MEETING NOTICE AND AGENDA

- d. Award of Bid for the construction of a 1.0MG Water Tank located above the Orchard Ridge development, and construction inspection services – Public Works.

KAYSVILLE CITY COUNCIL
February 20, 2020

SET NO.	DESIGNED	DRAWN	CHECKED	SHEET NO.
07062	SH	TR	CL	10 of 44
				PP2

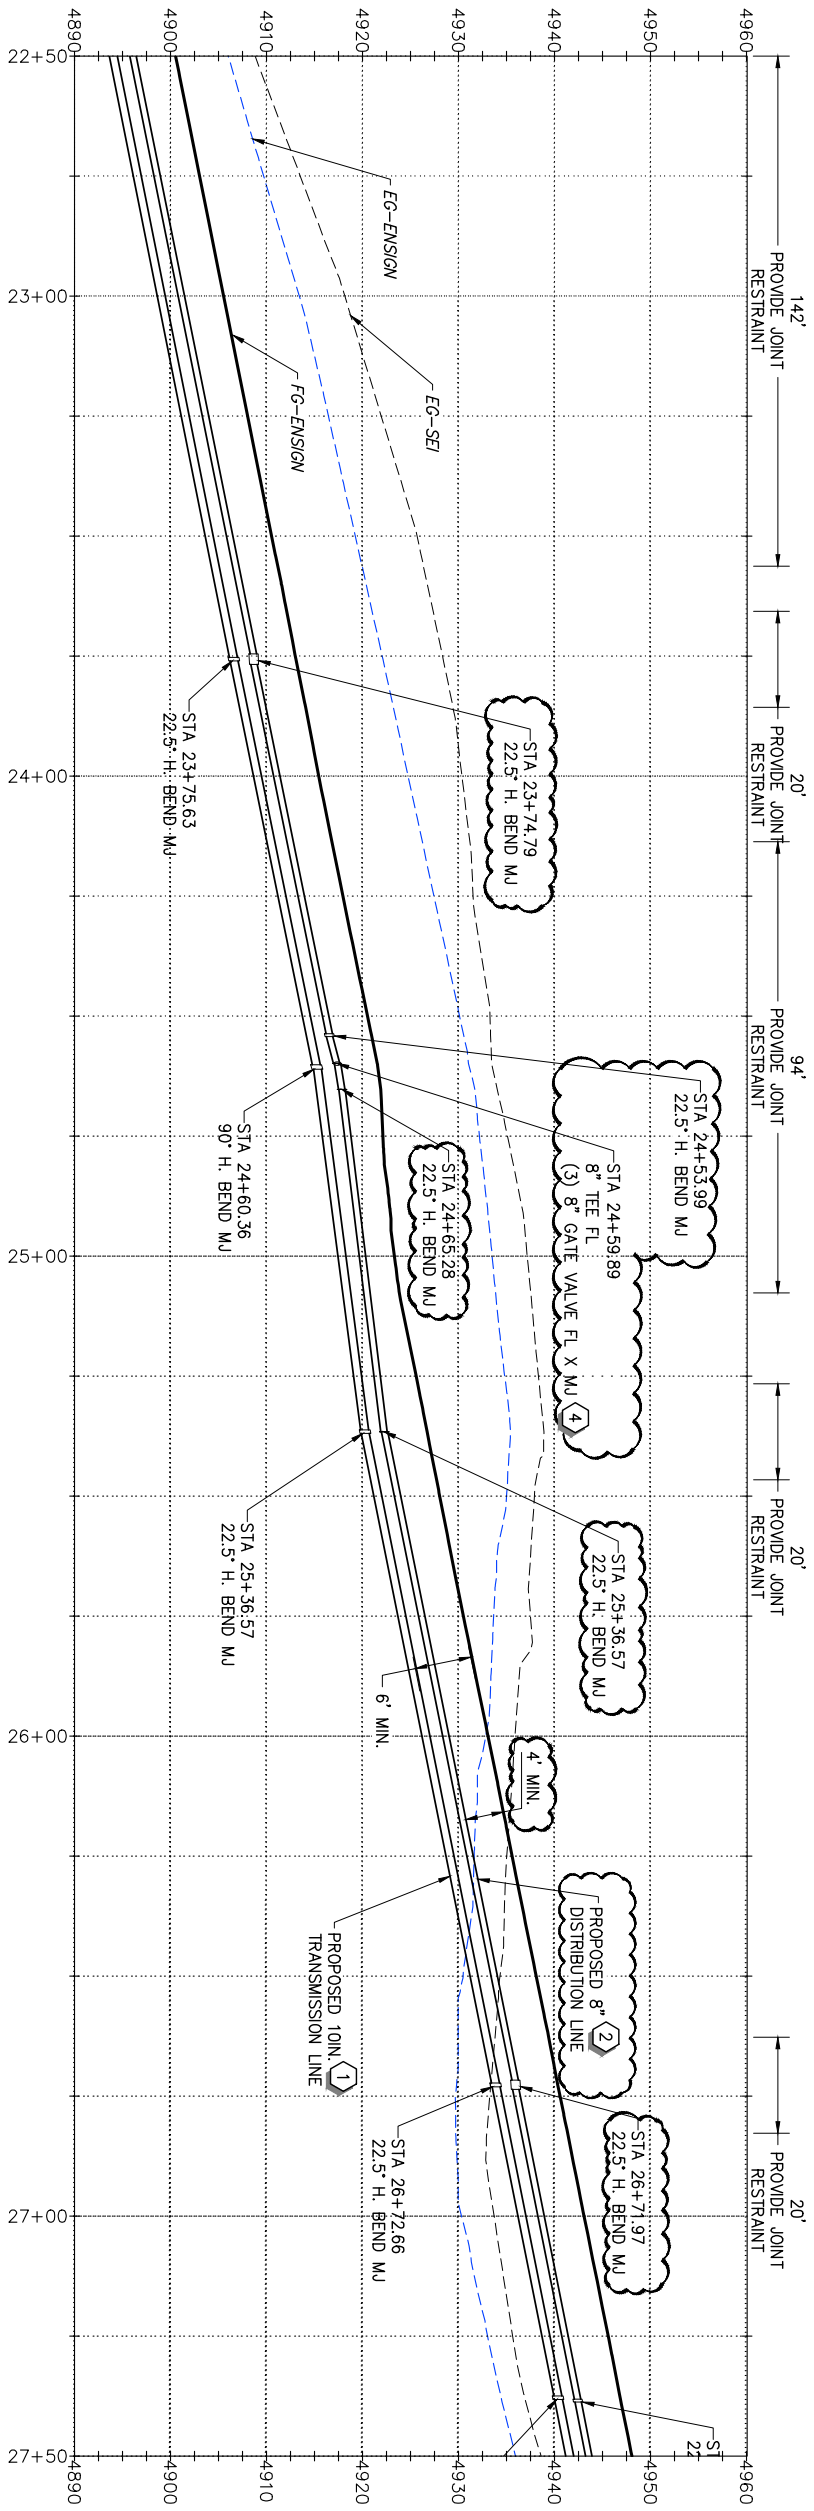
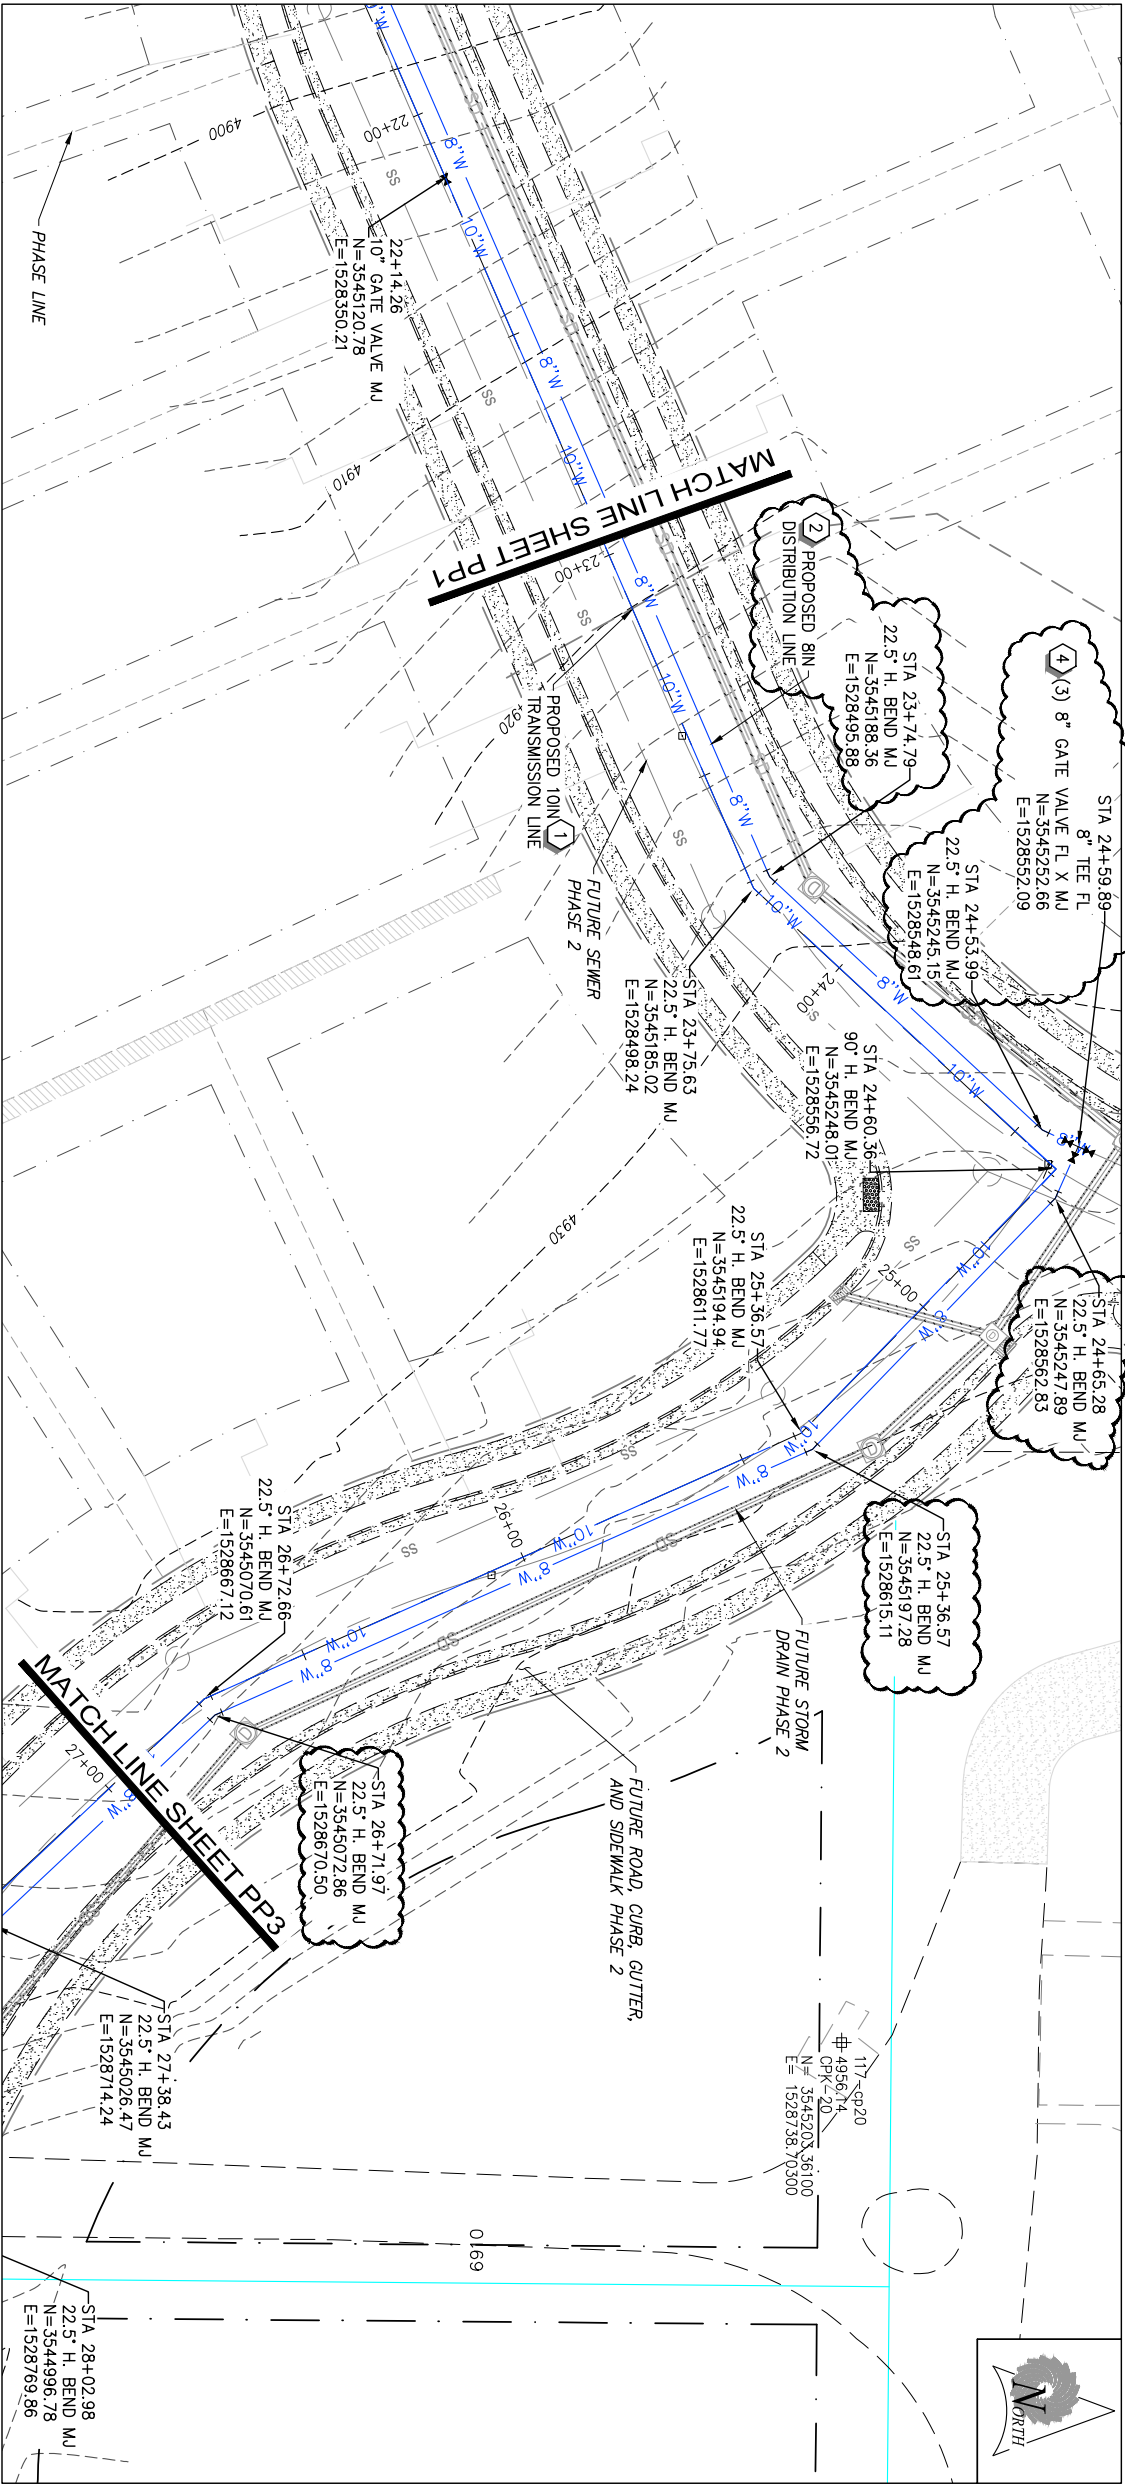
4.2 Revised Sheet PP2 of Booster Station Project

SET NO.	DESIGNED	DRAWN	CHECKED	SHEET NO.
07062	SH	TR	CL	11 of 44

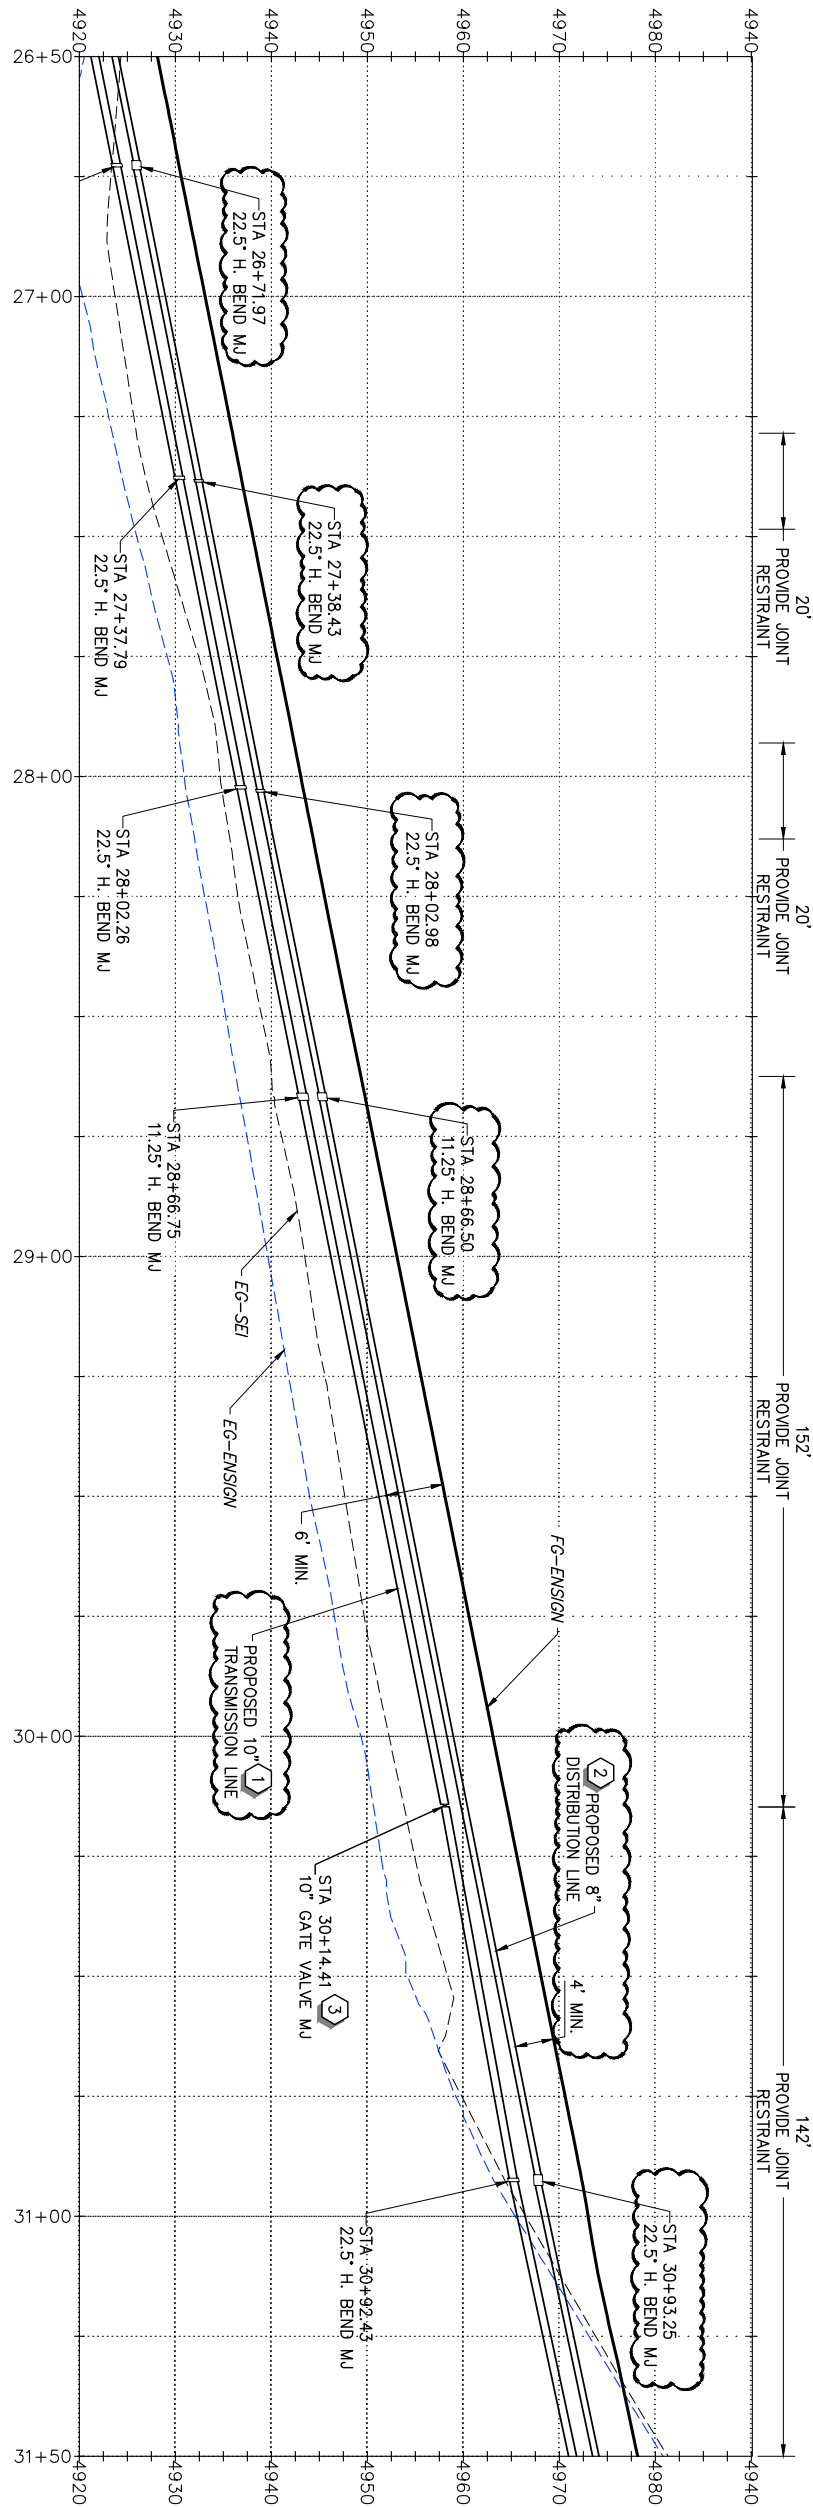
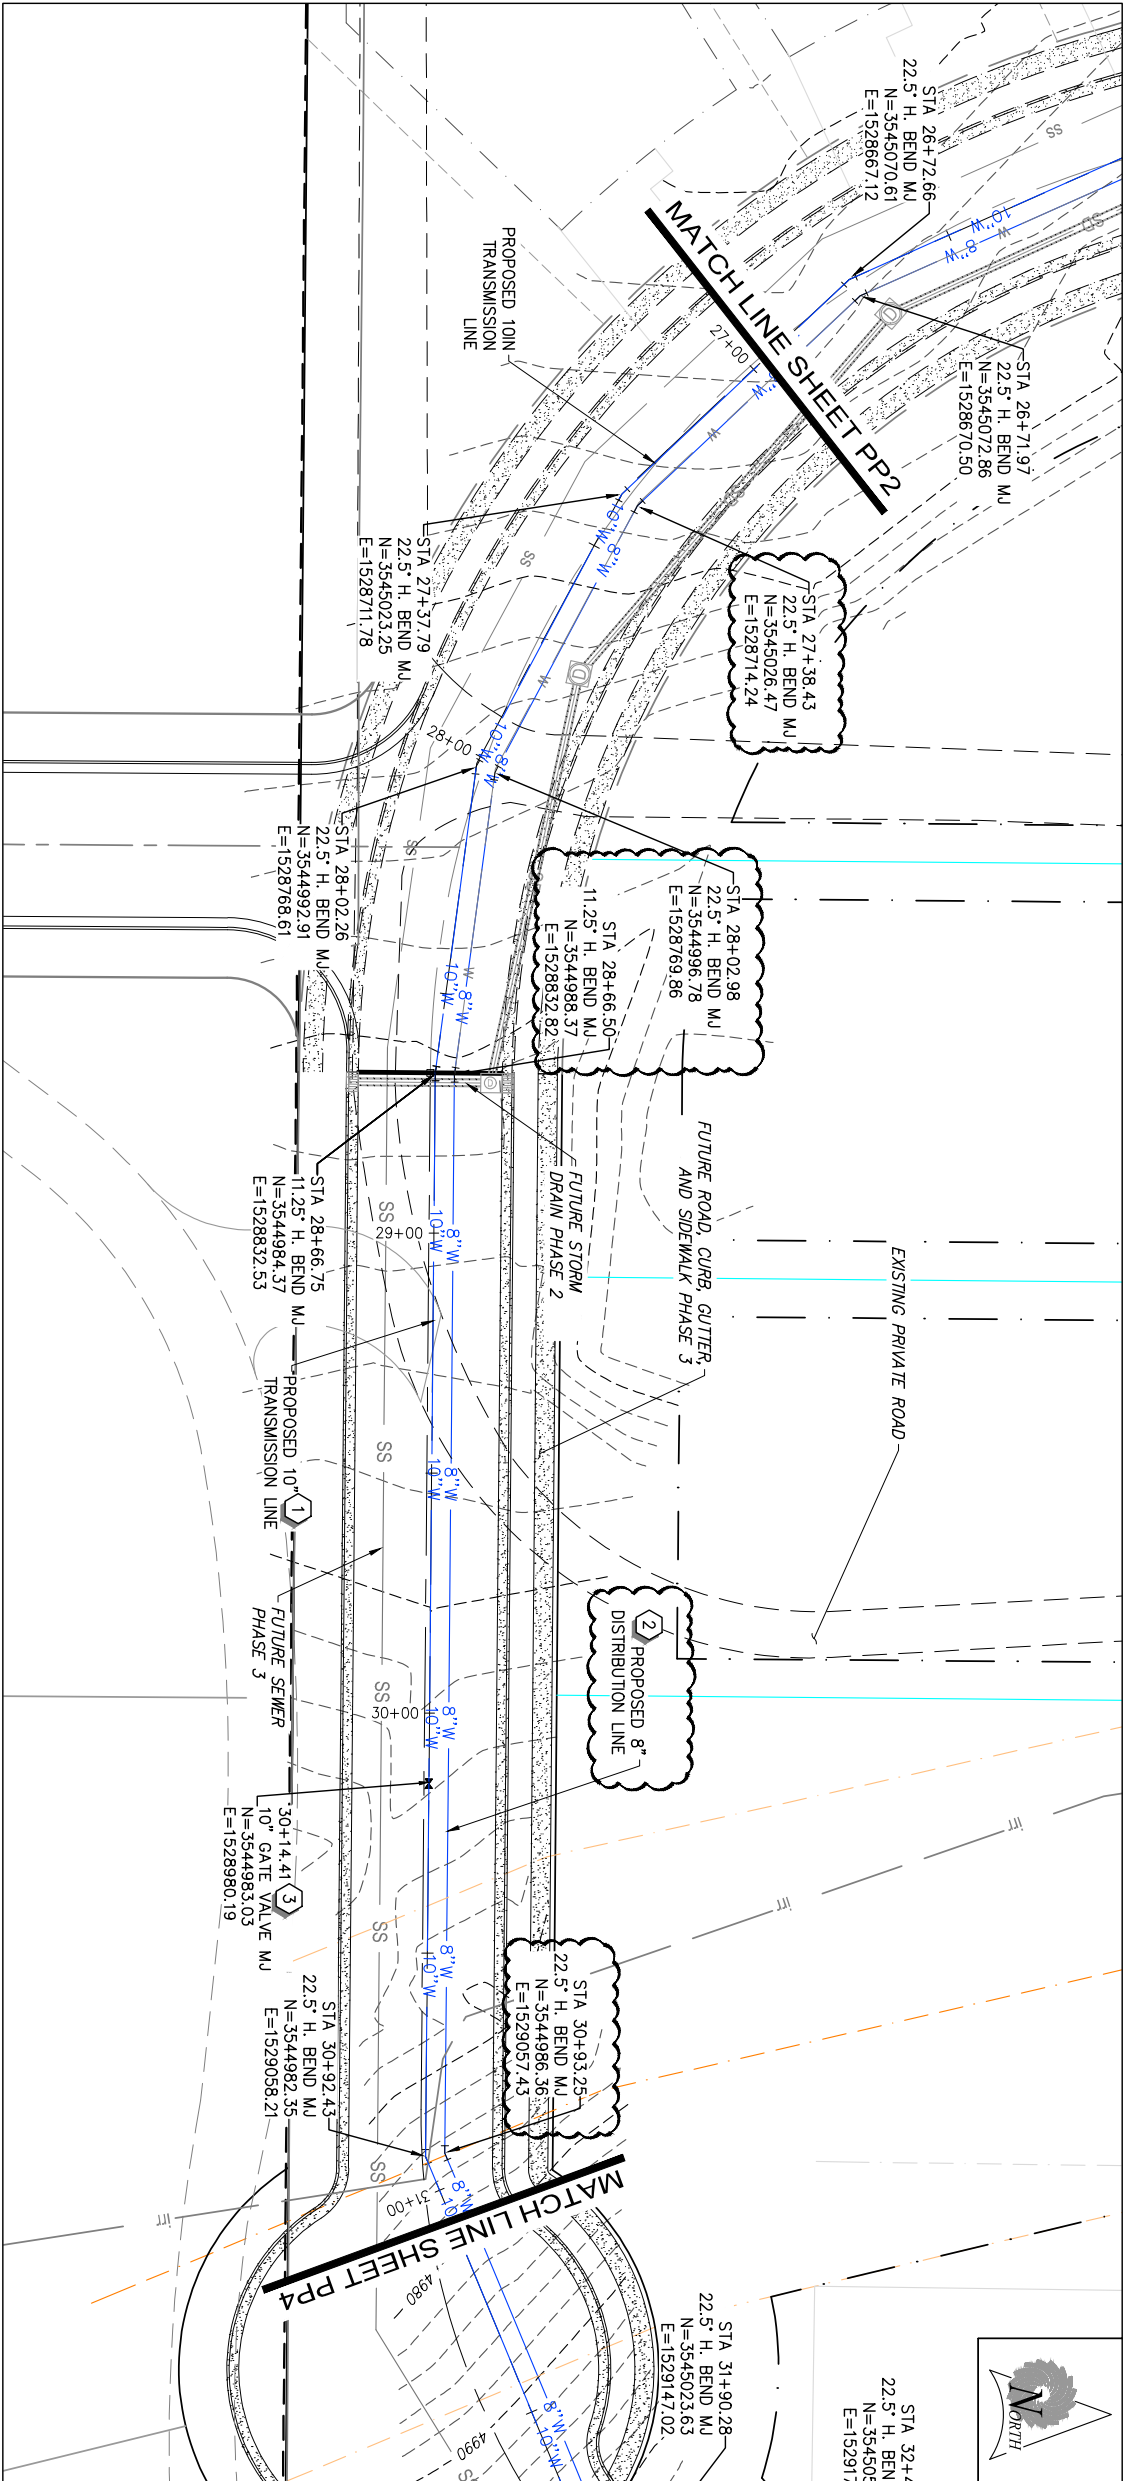
4.3 Revised Sheet PP3 of Booster Station Project
